Stallan-Brand

Date: 25/03/2024

2027.00 Moss Lane East, Manchester

Design and Access Statement Addendum

Mezzanine Plan within Proposed Amendment

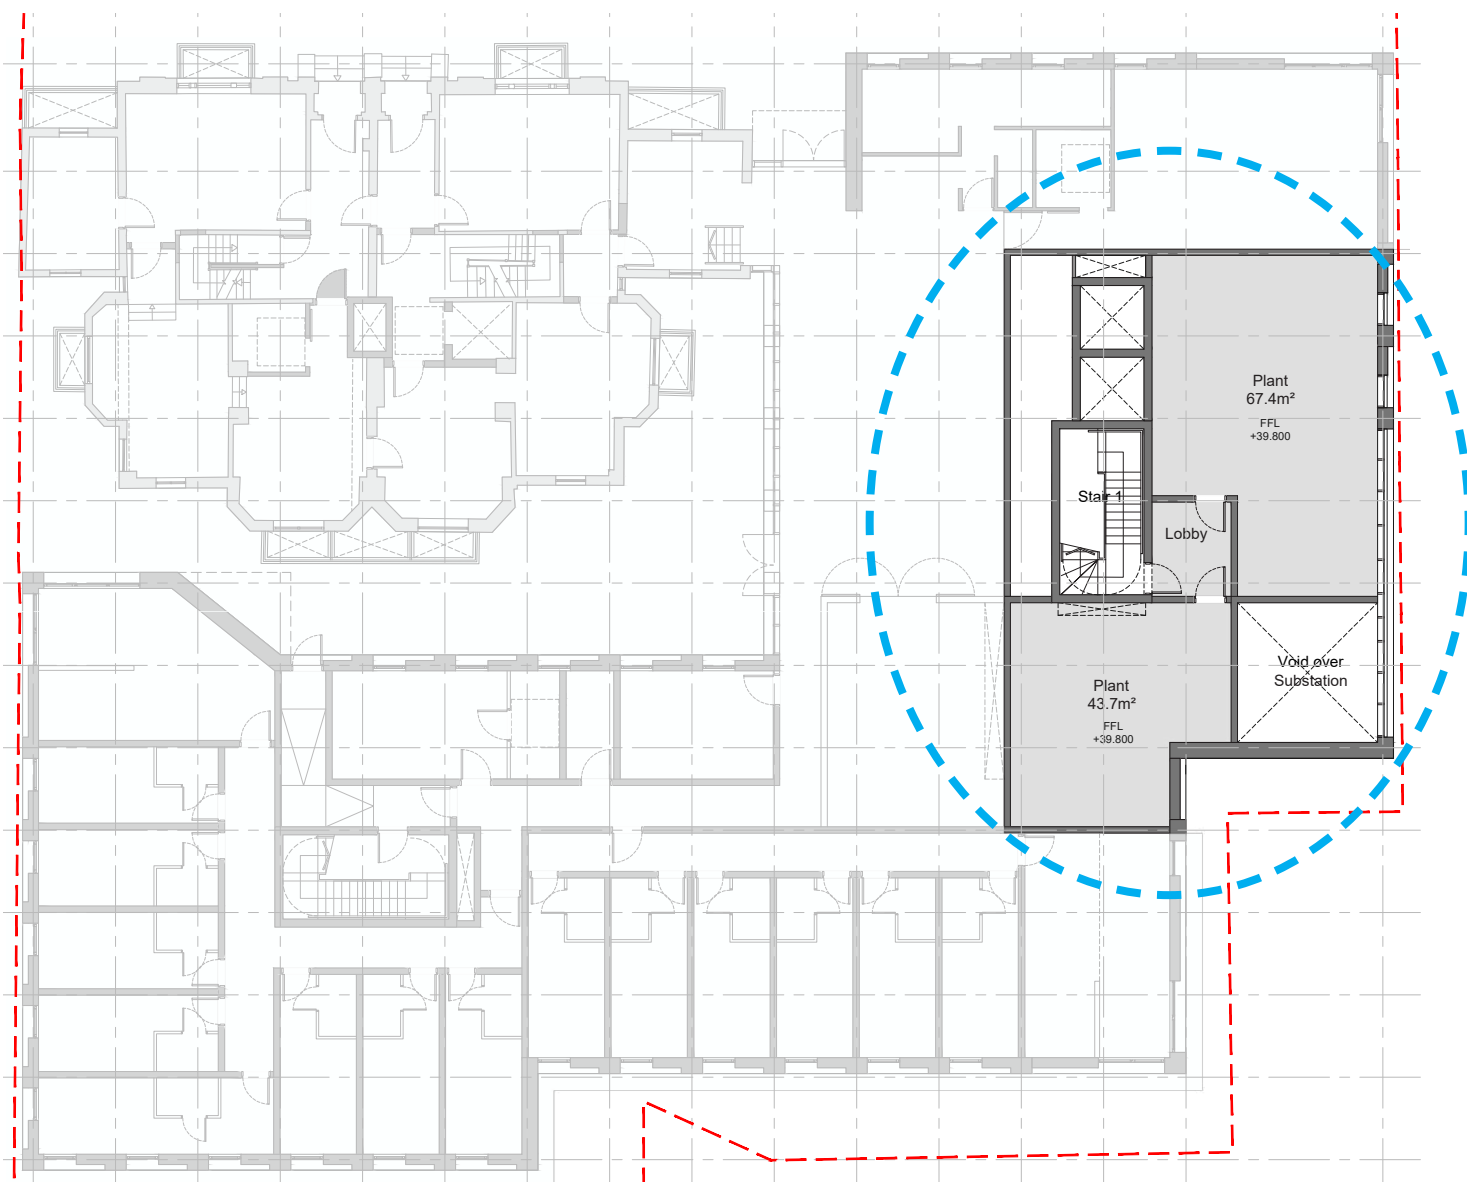
To rationalise and simplify the operational strategy for refuse collection and cycle storage use and access, and to optimize the building diagram, the following has been proposed -

- Omission of Basement
- Relocation of ancillary spaces to Ground Floor and new Mezzanine level

This is accommodated by the following amendments -

- Refuse and Cycle Store relocated to Ground Floor (note: shown on following pages)
- Ground floor amenity areas reconfigured
- Plant room relocated to new Mezzanine level and part of plant relocated to rooftop

Ground Floor Plan as Amended

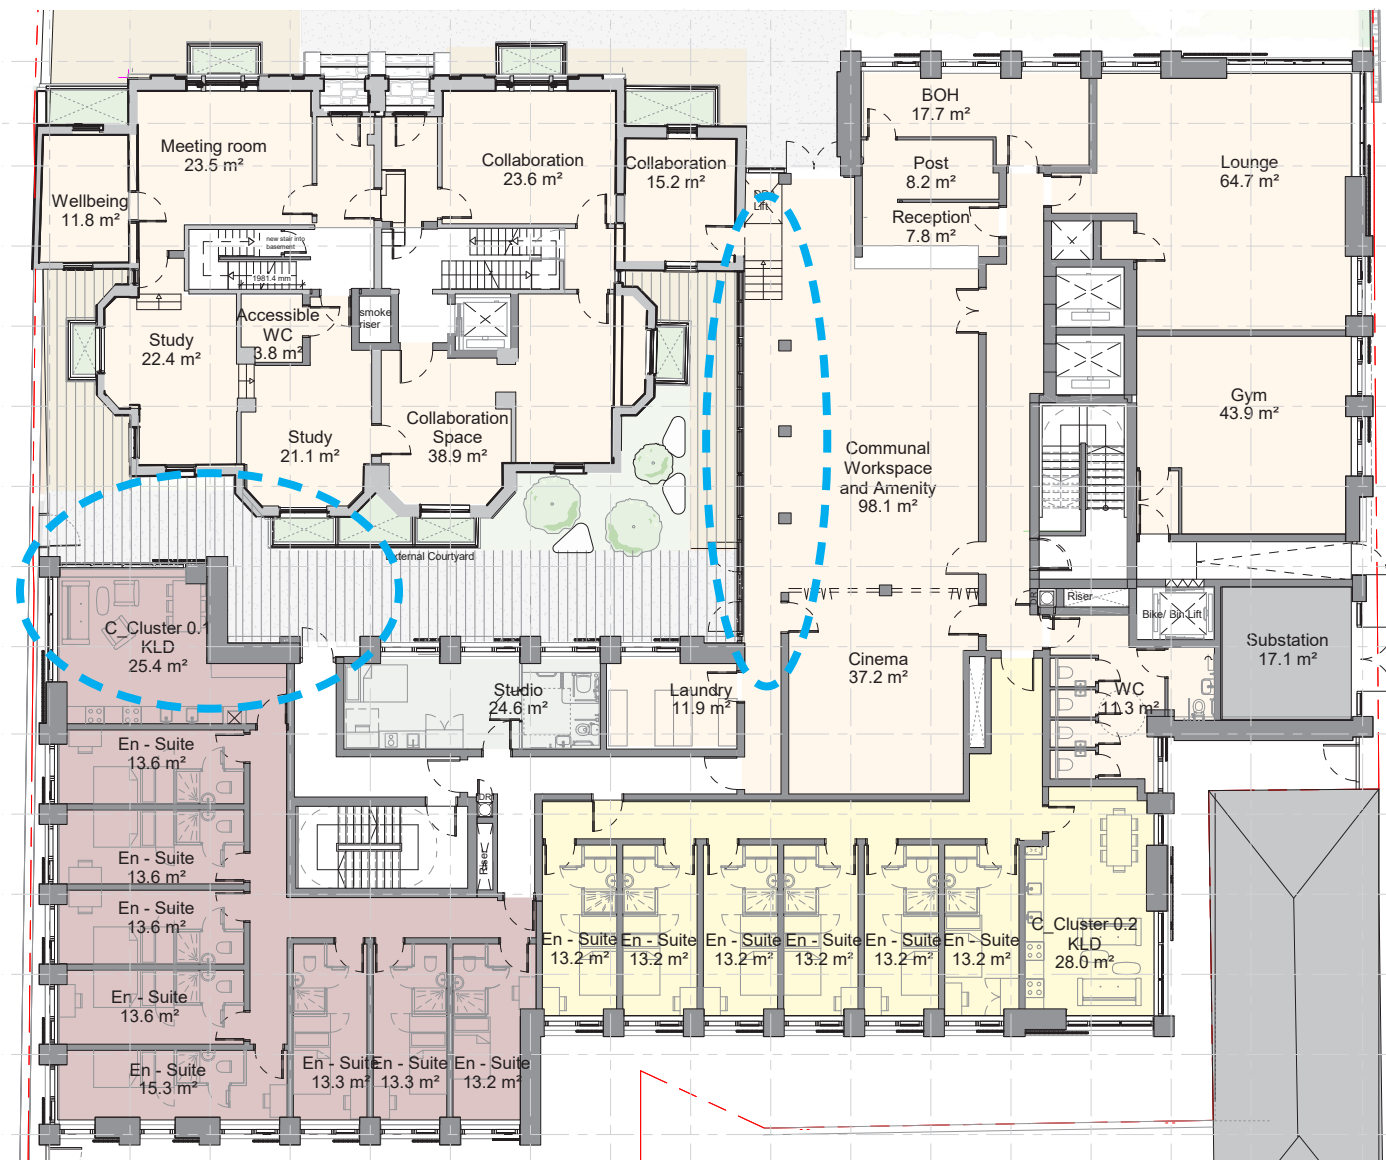
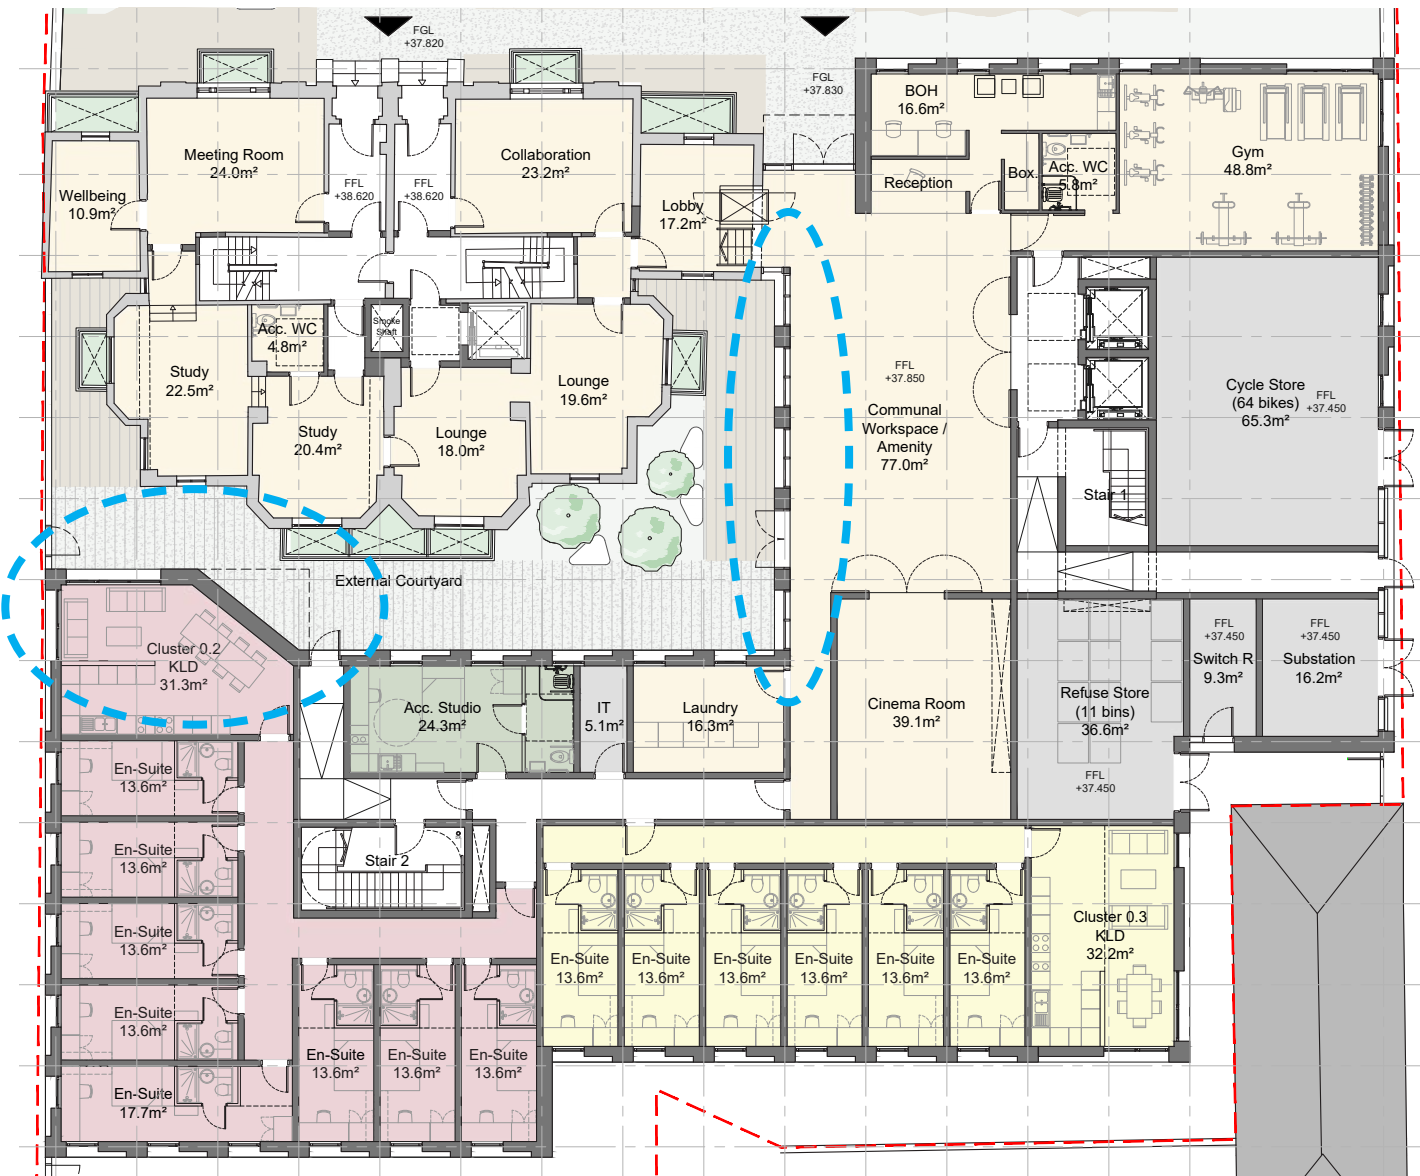
To ensure Building Regulations compliance for fire escape, the following has been proposed -

- Adjustment to building corner geometry adjacent to Stair 2 exit to provide sufficient offset from the listed building

To ensure co-ordination with structural strategy and to increase courtyard area, the following has been proposed -

- Adjustment to west-facing courtyard glazing

- Building corner chamfered
- Courtyard glazing aligned with building line above

The below floor plans also show the proposed amendments associated with omission of the basement -

- Refuse and Cycle Store relocated to Ground Floor
- Ground floor amenity areas reconfigured

Section B-B as Amended

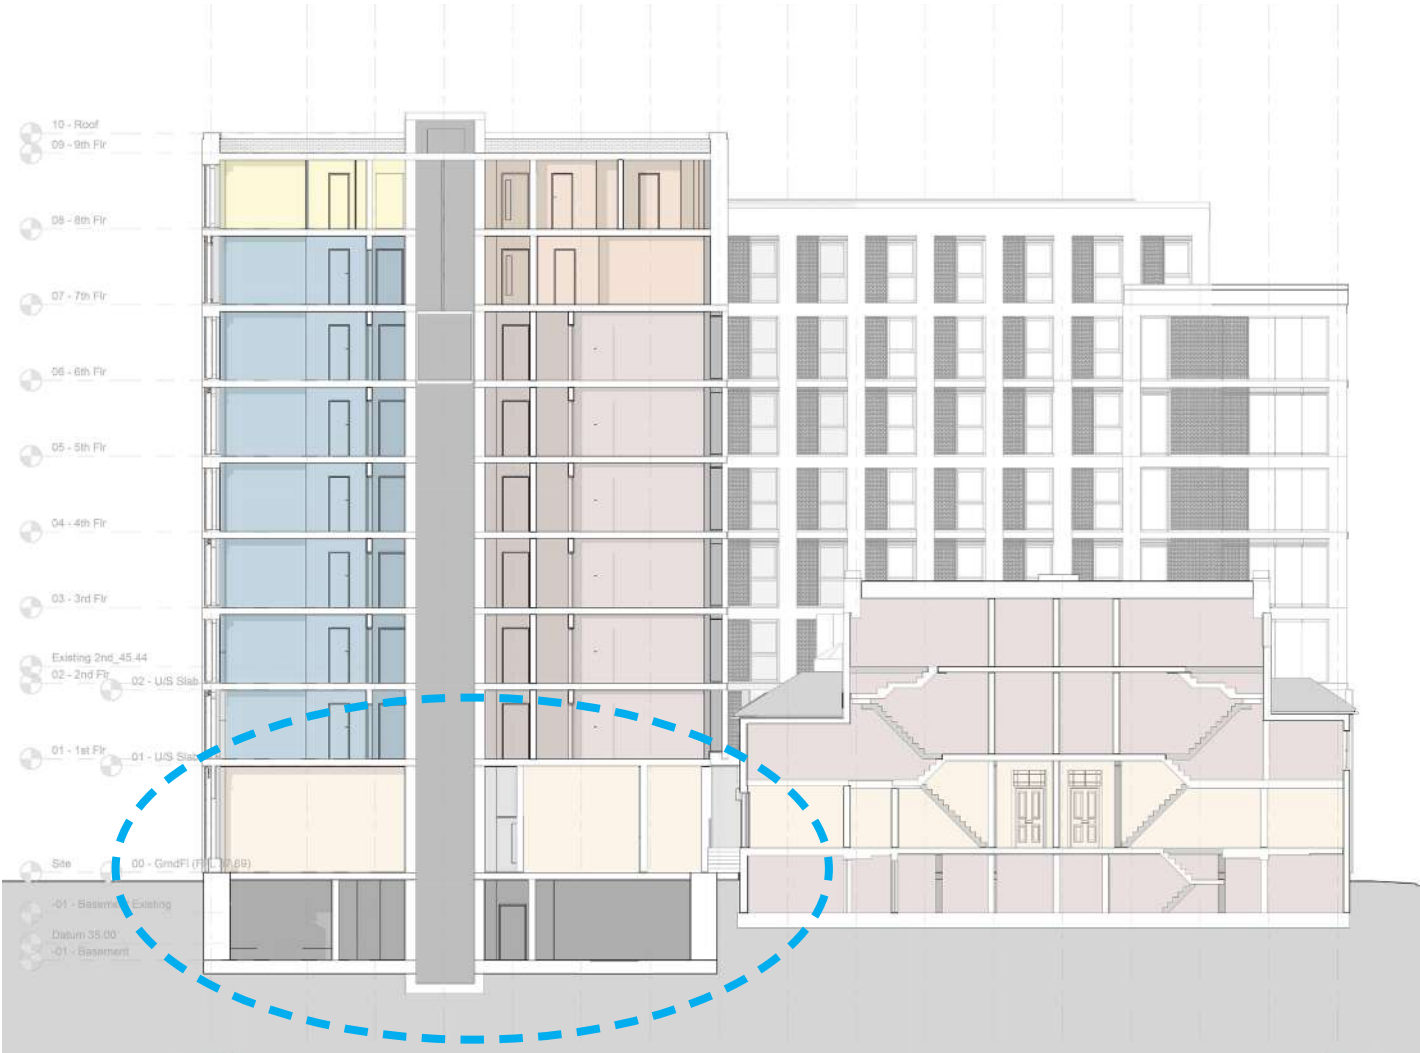
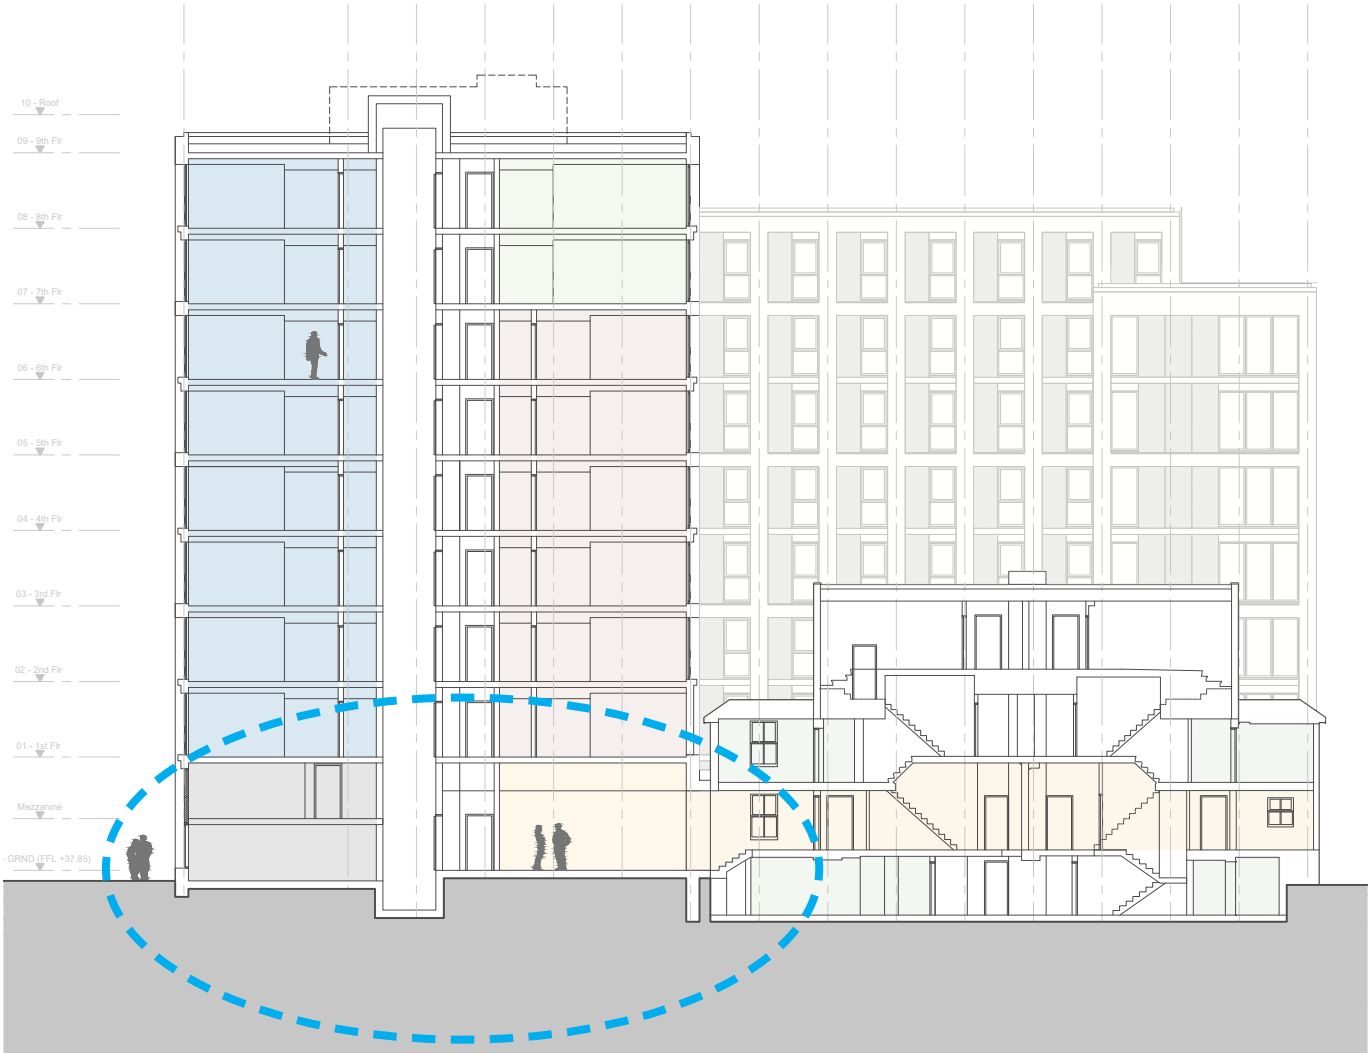
Lower Levels cont.
The previously mentioned amendments are shown in the below sectional diagram, including -

- Omission of basement
- Insertion of Mezzanine level
